RE: APPLICATION FOR DEVELOPMENT APPROVAL – LOT 15 (#31) BEDFORD STREET, CUNDERDIN WA 6407 & REQUEST FOR FURTHER INFORMATION BY EXURBAN

**REQUEST FOR FURTHER INFORMATION RECEIVED VIA EMAIL BY EXURBAN ON
5/10/2024**

Proposed Shop

Drawing No.: TP018-SP-01A

SITE PLAN

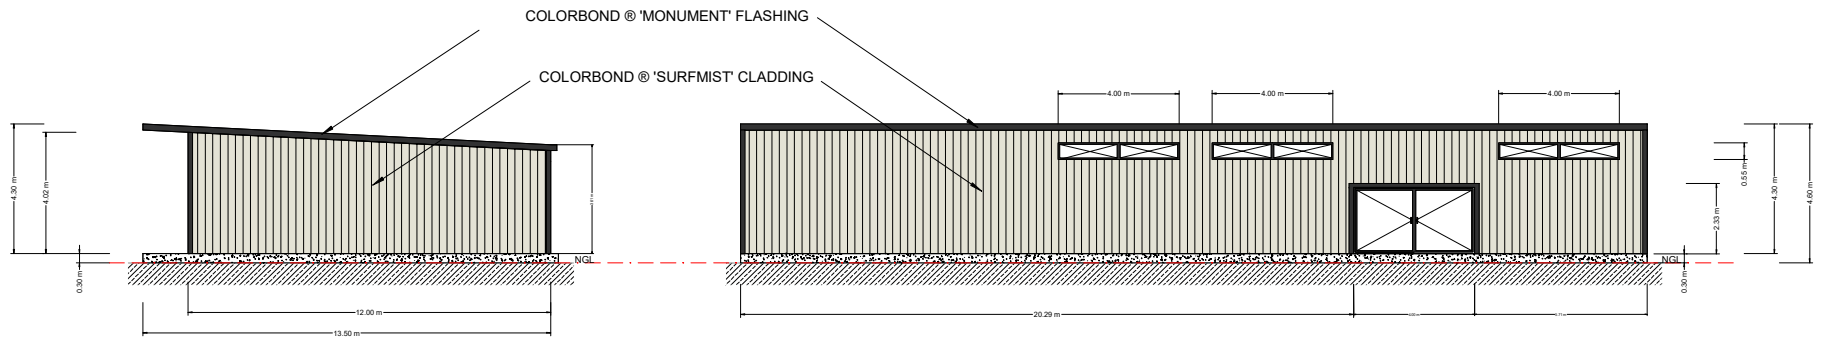
<p>requires all transport vehicles associated with any commercial development to be able to proceed in a forward gear when entering and leaving any commercial premises. In my view the proposed loading/unloading area may not allow for that depending upon the size of the transport vehicles that will visit the property. Heavy vehicle parking and loading/unloading in the Bedford Street road reserve area will not be supported due to the potential vehicle and pedestrian safety risks. Modifications to the site development are therefore likely to be required to satisfy the requirements of Local Planning Scheme No.4 unless you can clearly demonstrate by way of swept path movement plans the largest transport vehicle that will attend the property will be able to enter and leave the property in a forward gear;</p>	<p>vehicle that will access the unloading area are 3.5 tonne vehicles (i.e. Mercedes Benz Vito, Fiat Ducato and similar). These vehicles are, on average, 5.45 m in length, 2.050 m wide and 2.250 m in height.</p> <p>I have shown 'sweep path' lines on the Site Plan to demonstrate that these types of commercial vehicles can comfortably enter in a forward gear, manoeuvre to reverse up to the docking area, and then exit the premises in a forward gear.</p>

<p>The discharge of stormwater drainage to the north-eastern corner of the property and into the existing drain on Lot 8 (No.12852) Great Eastern Highway which I note is privately owned is not acceptable and needs to be addressed unless there is a formal agreement in place with the adjoining landowner including a suitable drainage easement registered on title that benefits and burden each lot respectively. I appreciate that historically drainage has been directed to the adjoining property however with all the hardstand areas now proposed on the subject land and the significant increase in the amount of stormwater that will be directed to the adjoining property due to the new impervious surfaces on the subject land this arrangement cannot prevail. A stormwater drainage management plan prepared by a suitably qualified person is therefore required in support of the development application which is what I previously requested needs to be provided.</p>	<p>I note your comments acknowledging that, historically, drainage has been directed to the adjoining property.</p> <p>I know I cannot instruct you in any way, Joe, but during my time in local government, I have consistently and regularly imposed conditions of development approval on large scale residential and commercial development as follows (example only):</p> <ol style="list-style-type: none"> 1. Prior to the commencement of development, detailed drainage plans shall be submitted to the satisfaction of the local government. 2. Prior to occupation, stormwater drainage works must be completed in accordance with the approved plans to the satisfaction of the local government. 3. The on-site drainage system shall be maintained on an ongoing basis to the satisfaction of the local government. <p>The owners are aware that they cannot discharge stormwater onto adjoining properties in an uncontrolled manner.</p> <p>In this regard, we are guided by your advice to the Council of the Shire of Cunderdin. Now would be a good opportunity for the Shire to consider how they wish to deal with the wider catchment and discharge of stormwater via the existing system in that</p>

The table that provides details of all boundary setbacks needs to be updated to account for the proposed setbacks to both side boundaries, not just the eastern side boundary as is currently the case.	This has been updated.
The height of the proposed new fencing and access gates along the land's front boundary needs to be shown.	Refer updated Site Plan.
A key objective of the land's 'Commercial' zoning classification is to maintain the compatibility with the general streetscape for all new buildings in terms of scale, height, style, materials, street alignment and design of facades. The Scheme also states the front façade of all buildings shall reflect and be compatible with the predominant existing streetscape and architectural style and the local government may impose conditions relating to building setbacks, design, scale, materials and finish to ensure compatibility with the existing streetscape and general architectural style. In my opinion the front façade of the proposed new shop building does not adequately address and satisfy the abovementioned zone objectives or development requirements. The building looks like an industrial shed when viewed	We contend that the proposed development will not be detrimental to the amenity of adjoining owners or residential properties in this part of Cunderdin. We would also contend that the proposed development is already compatible with the general streetscape of that part of Bedford Street, and in particular the existing development on Lot 14 (35) Bedford Street. In our opinion, we believe the proposed design and style of building would present well on Bedford Street and contribute positively to the existing streetscape.

part of Cunderdin townsite, be it by formal agreement with the owner of 12852 GEHWY or suitable drainage easement to burden affected properties.
I note there is very limited information regarding the types of plants to be used in the proposed landscaping areas. Again, a landscaping plan prepared by a suitably qualified person is required however I'm happy to recommend a condition be imposed on any development approval that may ultimately be granted requiring a landscaping plan to be prepared and submitted to the Shire for consideration of approval prior to the commencement of development.	Happy for you to condition the landscaping.
The dimensions of all car parking bays needs to be shown to demonstrate compliance with Australian Standard AS2890 for off-street parking facilities which is a specific requirement of Local Planning Scheme No.4.	The car parking bays on the Site Plan are 6 m long and 3 m wide. I have included annotations on the Site Plan to depict dimensions.

ELEVATIONS

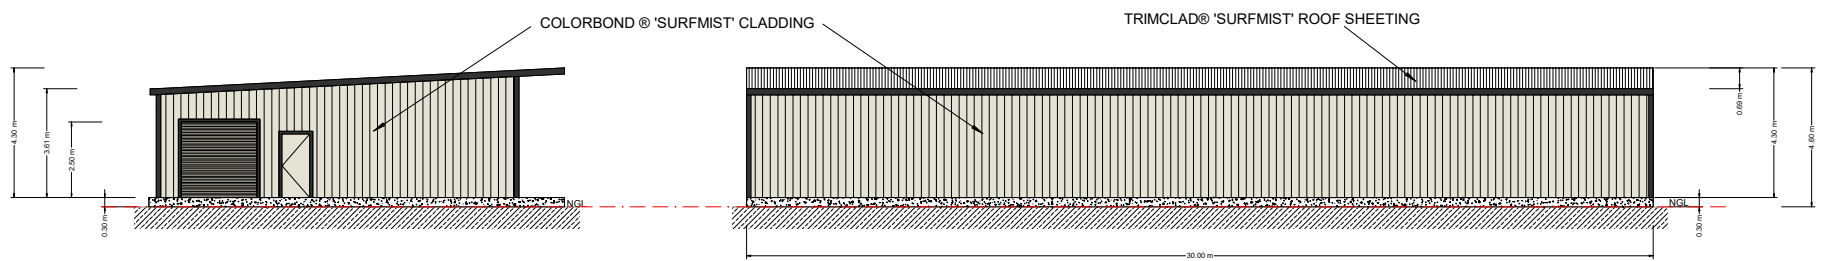
<p>from the land's Bedford Street frontage and is simply visually unattractive and adds little to no value to the local streetscape. As such I'm not prepared to recommend approval to the application unless this issue is suitably addressed. Please also be sure to show on the elevation drawings the colour to be used for all the proposed roof sheeting which I note is not specified on these drawings.</p>	
<p>Lastly, I note no information regarding any proposed new advertising signage has been provided in the application. I expect advertising signage will be installed at some point so you can either provide this information now, including a completed and signed Form 2 application form, or confirm in the covering letter that approval will be sought at a later date for all proposed new advertising signage once specific details have been confirmed.</p>	<p>My client has indicated that he will submit a separate application for advertising signage if it is of a type and class not exempt by Schedule 1 in LPS4.</p>
